LEE'S SUMMIT
MISSOURI
Development Services Department

Development Services Staff Report

File Number	PL2023-319
File Name	PRELIMINARY DEVELOPMENT PLAN – Outlaw Harley Davidson
Applicant	Engineering Solutions, LLC.
Property Address	3100 NE Carnegie Dr.
Planning Commission Date Heard by	January 25, 2024 Planning Commission and City Council
Analyst	C. Shannon McGuire, Senior Planner

Figure 2 – Parking lot encroachment adjacent to NE Strother Rd.

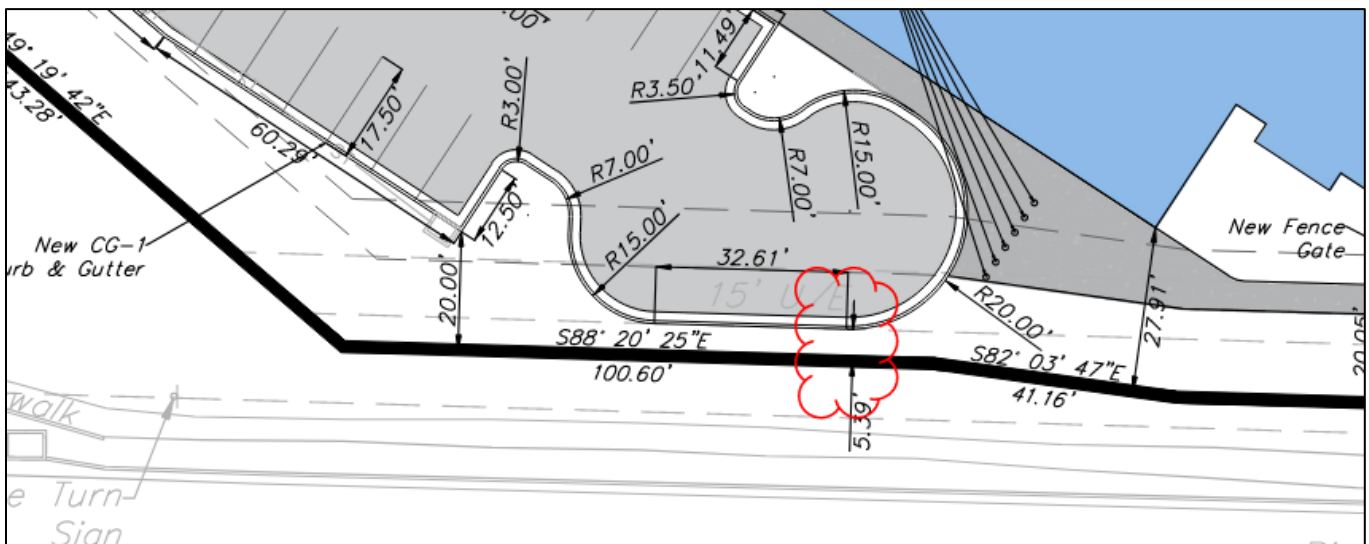
1. The applicant has requested a modification to UDO Sec. 8.620 – Parking lot design.
 - **Required** – 20' minimum setback from public right-of-way.
 - **Proposed** – 5.39' setback from the NE Strother Rd. right-of-way.
 - **Recommended** – The proposed encroachment in to the parking lot setback is to allow for a better turn around access for emergency services. The setback is adjacent to the NE Strother Road Right of Way and in this specific location the right of way is 21.50 feet from the back of curb, where typical right of way is 11 or 12 feet behind the curb. This modification will not create an adverse effect on safety and will provide better emergency services access to the site. For these reasons staff supports the requested modification.

1. A modification shall be granted to the minimum 20' parking lot setback from right-of-way, to allow a 5.39' parking lot setback from the NE Strother Rd. right-of-way.

Figure 3 – Renderings of south exterior elevation

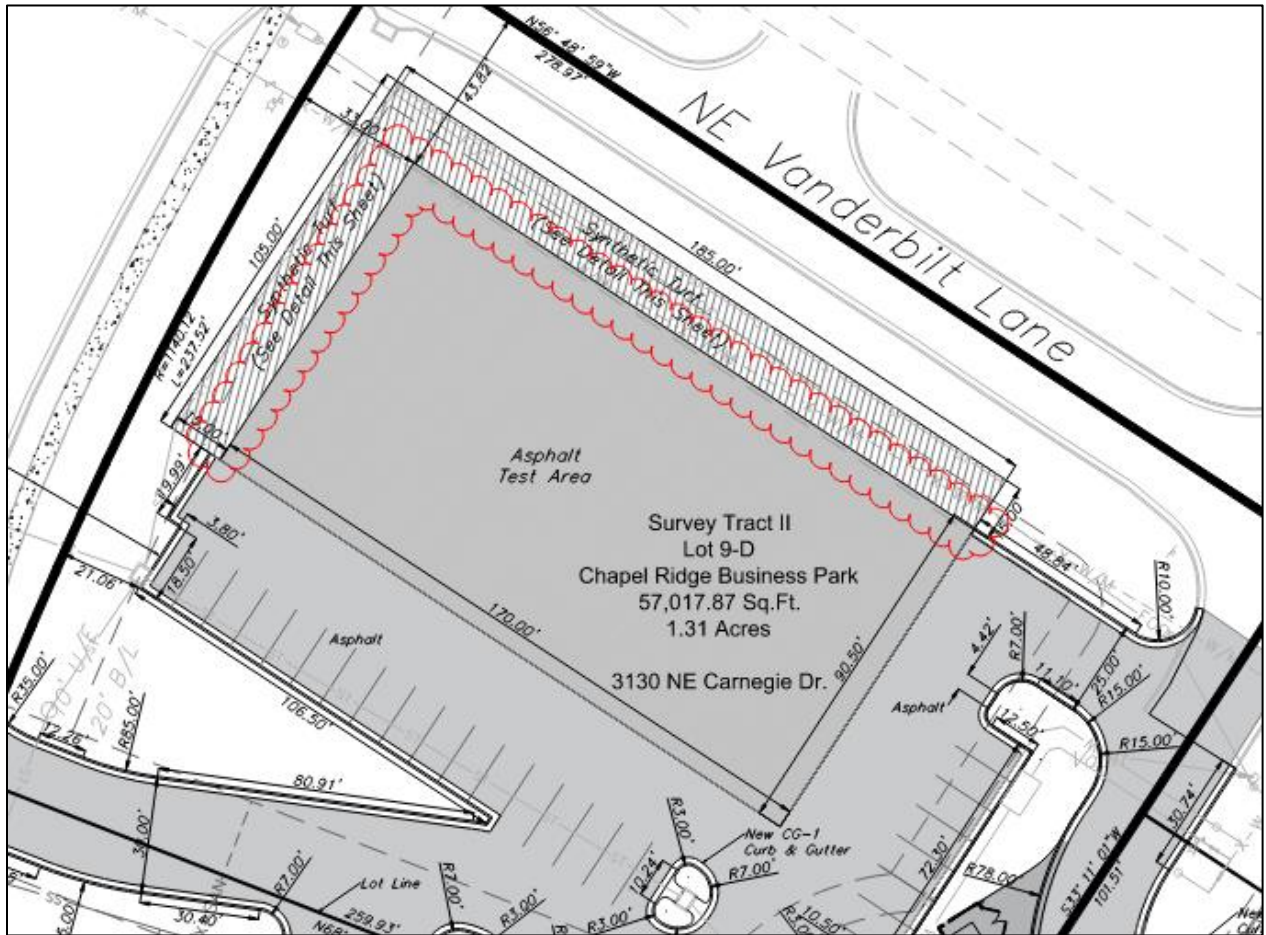
3. The applicant has requested a modification to UDO Sec. 8.180 - Architectural Characteristics.

- **Required** – All roof-mounted equipment shall be screened entirely from view by using parapet walls at the same height as the mechanical units.
- **Proposed** – The applicant has proposed to utilize bolt on screening in the place of a parapet wall.
- **Recommended** – With a larger building, constructing a parapet wall that encompasses the entire perimeter of the proposed roof line is excessive and not practical. The proposed screening system is opaque and provides adequate screening of the mechanical units while meeting the intent of the UDO requirement. This same modification has been granted in the past such as the Coleman Equipment development (PL2017-097) and Tailormade Landing (PL2023-162). For this reason, staff believes the modification is reasonable and supports the request.

3. A modification shall be granted to the requirement that all roof-mounted equipment be screened entirely from view by using parapet walls at the same height as the mechanical units, to allow the proposed screening system in lieu of parapet walls for screening around the periphery of the roof-top mechanical equipment as depicted on the submitted Building Elevations, dated November 17, 2023 & revised December 22, 2023.
